# TransTechnical Bulletin

TB17 7/99

**Application:** Mazda F4A-EL, G4A-EL  
**Subject:** Turbine Shaft O-Ring

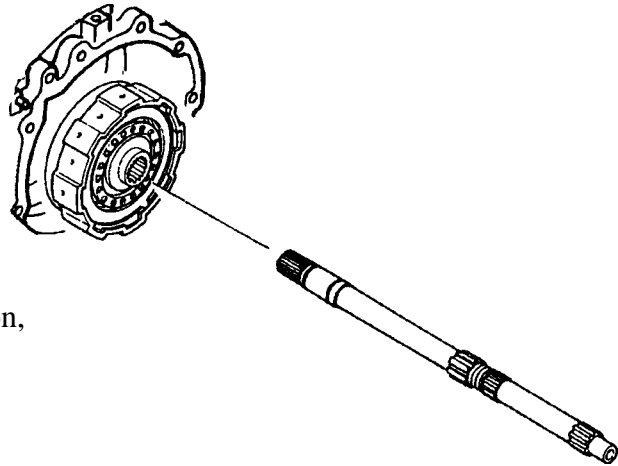
**Problem:** The turbine shaft O-ring that seals the oil feed to the 3-4 clutch pack on Mazda's F4A-EL and G4A-EL transmissions is prone to losing sealing ability due to prolonged exposure to high temperatures.

**Solution:** TransTec redesigned the O-ring to alleviate the problem. The new seal is slightly different dimensionally, and is now made of Viton, a more durable material. The redesigned O-rings will supersede the previous O-rings.

NEW VITON O-RINGS	
TransTec P/N	Application
17847	G4A-EL
17848	F4A-EL
